**CITY OF YPSILANTI**  
**Historic District Commission**  
**Regular Meeting Agenda**

**Tuesday, April 12, 2016**  
**7:00 p.m.**

# HDC Work Permit Staff Review

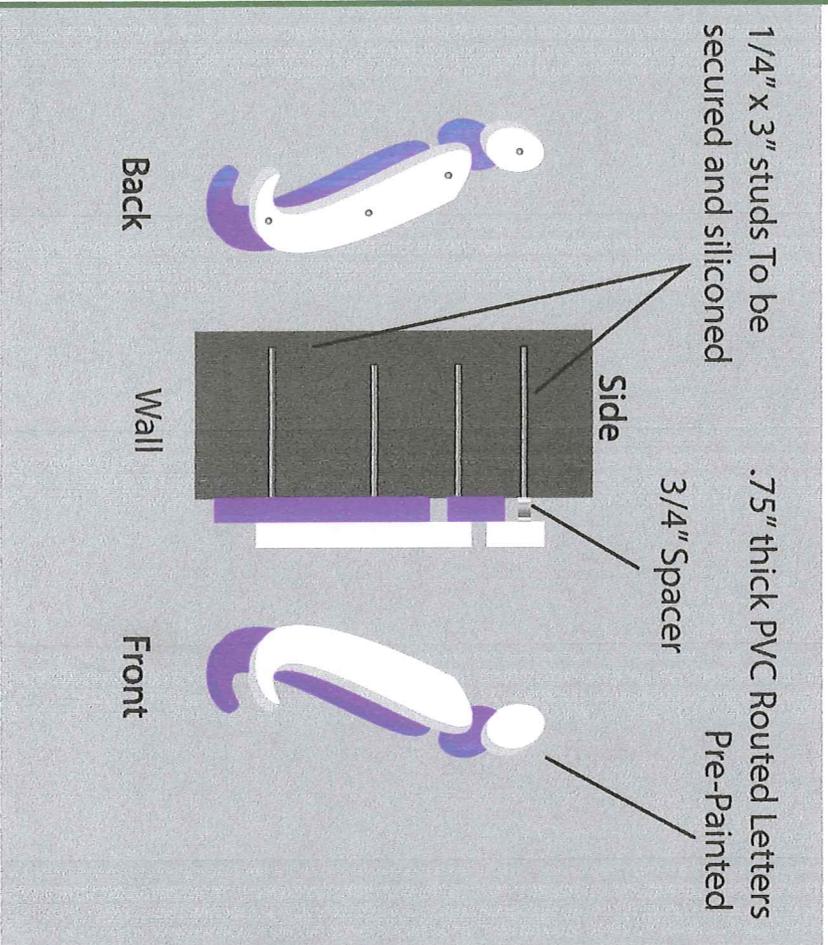
1. Application states that the proposed signage is made of ¾" thick PVC routed letters that are pre-painted in white and purple.
2. The new signage is to be attached to façade with ¼"x3" studs, which will be secured and "siliconed."
3. The application also mentions a ¾" spacer that will be installed behind the signage. The sign itself will be 48" wide and 60" long.
4. Before proceeding with work, applicant must seek the appropriate building department permits.

Suggested items to include in a motion to approve:  
Work to include the installation of a ¾" thick, pre-painted PVC sign in white and purple, which will be mounted to the front façade using ¼" x 3" studs and silicone. The sign will be 48"x60".

# Reface Existing Back-Lit Double Sided Projecting Sign

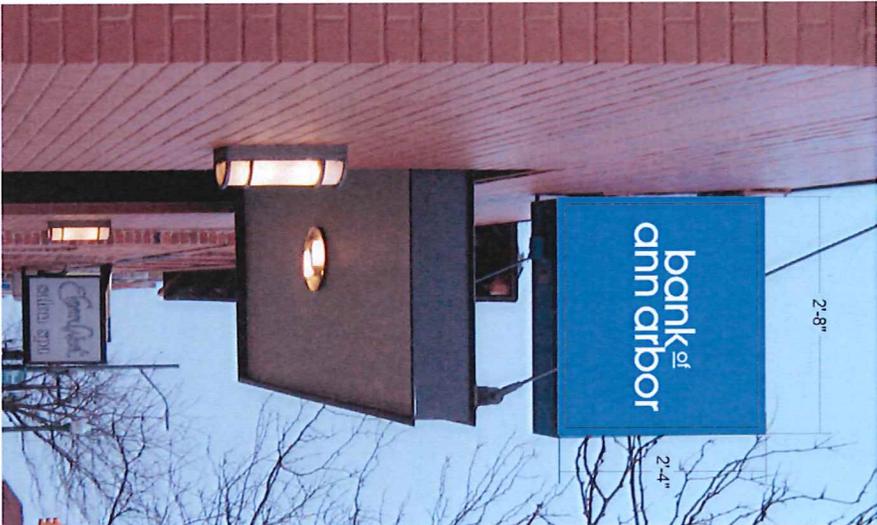
1. Application states that the lighting components of the projecting sign and wall sign will be removed and replaced with white LED panels. The existing logo will be replaced with a new logo. The new signs will be Lexan with vinyl graphics.
2. A new aluminum sign will be installed over the main entry way and will feature the new logo. The background is a 1" deep frame with flat cut 1/2" graphics.
3. All new signs will feature blue backgrounds with white lettering. The new signs also appear to be the same dimensions as the existing signs.
4. Before proceeding with work, applicant must seek the appropriate building department permits.

Suggested items to include in a motion to approve:  
Work to include the installation of three new signs at 7 W Michigan. Two signs—the projecting wall sign and the east wall sign—are to be Lexan with vinyl graphics. The sign above the main entry is to be aluminum sign board. The new signs are to match the existing signs in size and will feature new logos.

# 4 ft. x 6 ft. Black Aluminum Unassembled Metropolitan 2-Rail Fence Panel

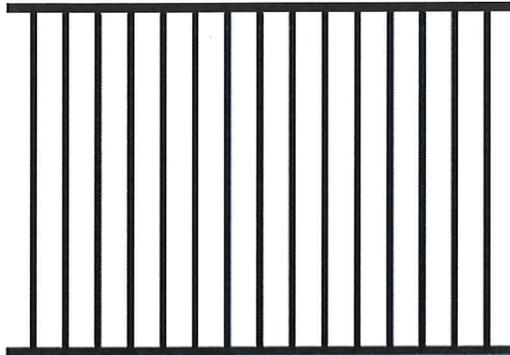
1. Applicant lists the use of a semi-transparent brown stain on the wood frame Green House—HDC may want to request an opaque stain be used on the wood.
2. Applicant states that they will be installing 12 feet of fencing adjacent to the Beer Cooler—HDC may want to specify exact location of fencing. The fence panels are 4' high and made of aluminum painted black.
3. Applicant states that they will be turning the antique blue garage door around so that the significant features face inward—they will then make the door flush with the interior wall, insulate the back of it and cover it with ribbed, corrugated steel panels (in red), or with masonry if a donation can be secured. HDC may want to inquire about the way the sheet metal will be attached to the masonry.

Work to include the installation of a 12' long, 4' high, aluminum fence, painted black, to be located adjacent to the Beer Cooler. Work also to include the construction of a 150 sq ft Green House, with a wooden frame and stained with a brown, opaque stain. The antique, blue garage door is to be turned so that it faces inward—the opening is then to be insulated and a sealed from the exterior with either corrugated, ribbed sheet metal in red, or with masonry.
